Entergy Nuclear Operations, Inc.  
(Indian Point Nuclear Generating Units 2 and 3)

SUBJECT: Entergy Nuclear Operations Inc.  
Indian Point Nuclear Generating Unit Nos. 2 & 3  
Docket Nos. 50-247 and 50-286  
**Amendment 3 to License Renewal Application (LRA)**

**Regional Inspection LRA Amendment**

**NRC Regional Inspection  
 License Renewal Application  
 Amendment**

**Figure 2.5-2**  
**IP2 Offsite Power Scoping Diagram**

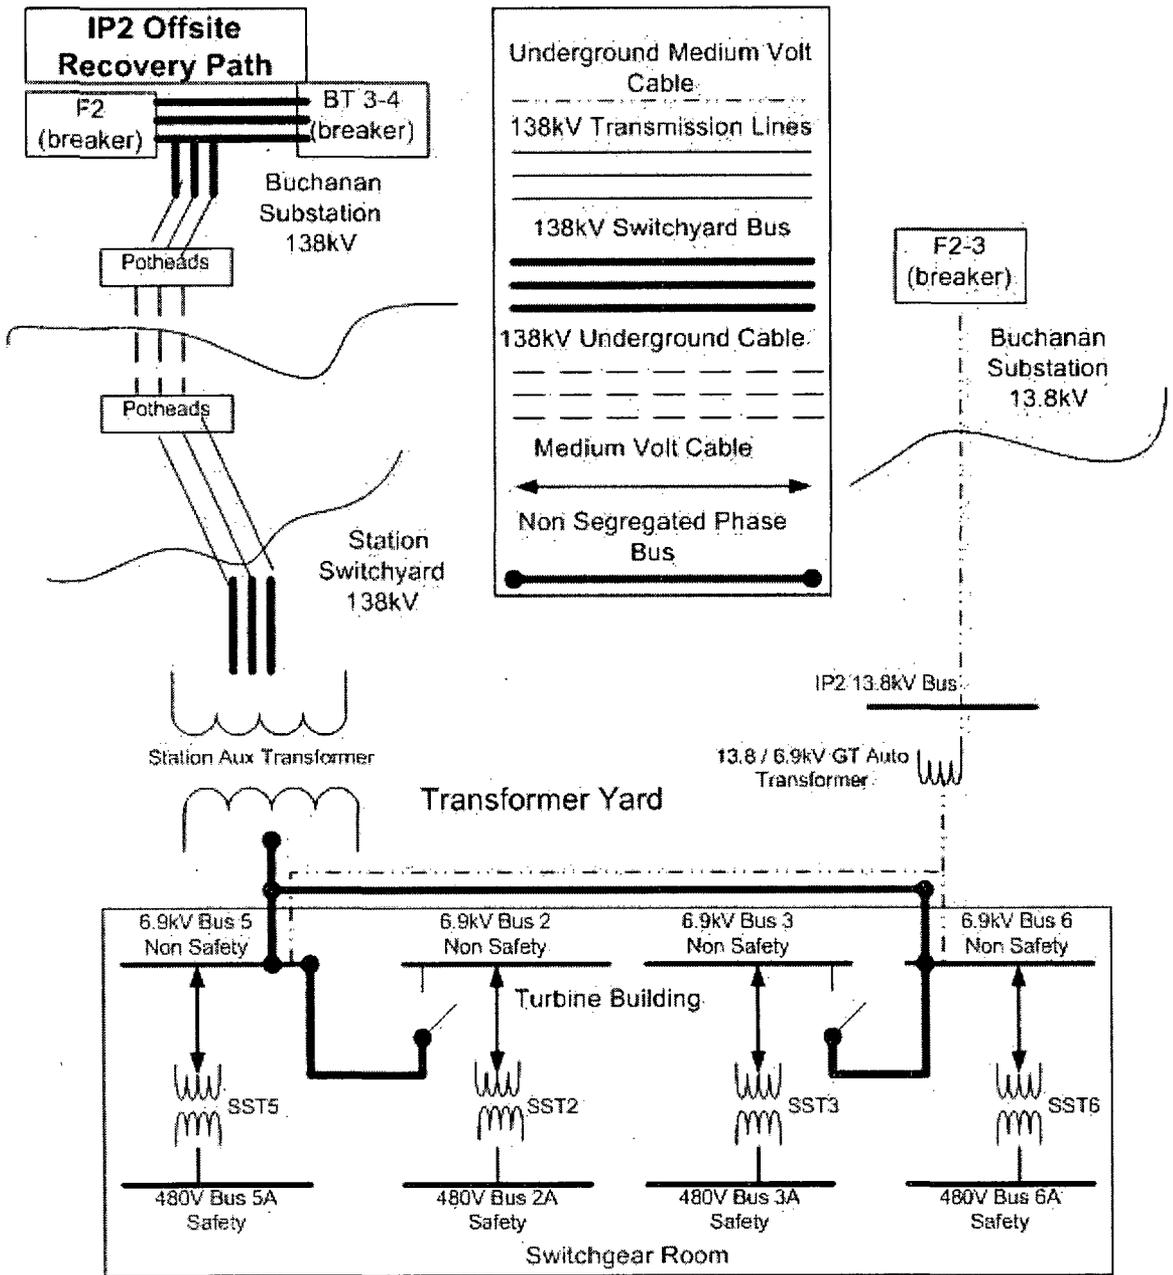
Based on discussion with the NRC Staff on 12/4/07 and industry discussion with the NRC Staff on 12/12/2007 and 1/30/2008, the response to this RAI provided in Entergy Letter NL-07-138, Dated 11/16/2007 is being revised. The only section that requires revision is LRA Figure 2.5-2 and associated discussion.

As shown in the revised LRA Figure 2.5-2, the 6.9 kV buses receive offsite power from either the 138 kV / 6.9 kV station auxiliary transformer or the 13.8 kV / 6.9 kV GT autotransformer. The station auxiliary transformer is connected to the 138 kV Buchanan substation, the primary offsite power source, via switchyard bus, overhead transmission conductors, and underground transmission conductors through ~~motor-operated disconnect F3A~~ switchyard breakers F2 and BT 3-4, which ~~is~~ are located at the Buchanan substation. The GT autotransformer is connected to the 13.8 kV Buchanan substation, the secondary offsite power source, via underground medium voltage cable through breaker F2-3, which is located at the Buchanan substation.
